THE TECHNICAL MATERIEL CORP.
MAMARONECK, NEW YORK

WOBBLE PLATE
COUNTER REDUCTION BOX

ELEC. DES. APP.	MECH. DES. APP.	
		PM-971 Ø

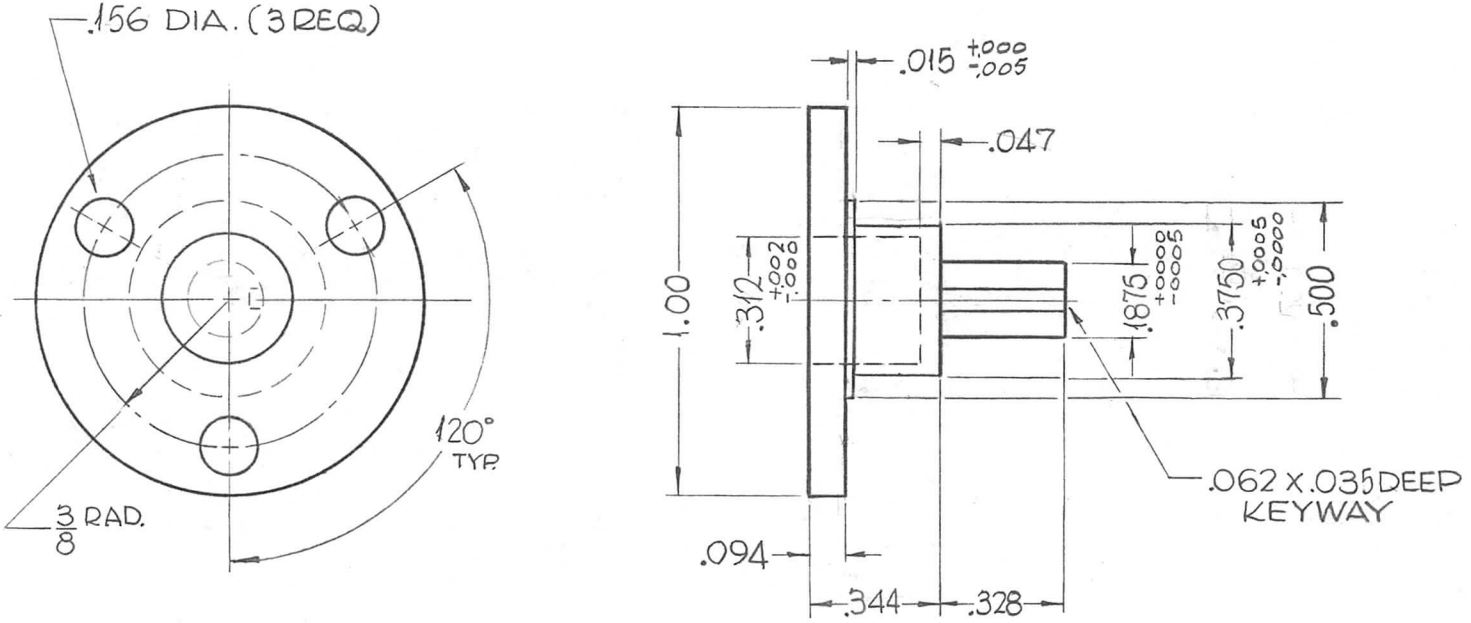
SYM	DESCRIPTION	DATE	CH. NO.	DRAFTS	CHECKER	ENG. APP.
O	ORIGINAL RELEASE FOR PRODUCTION	1/3/64				
X1	.156 HOLE WAS .140, .015 ADDED .035 DEEP WAS .031, .312 WAS .328	2-12-64		SRG
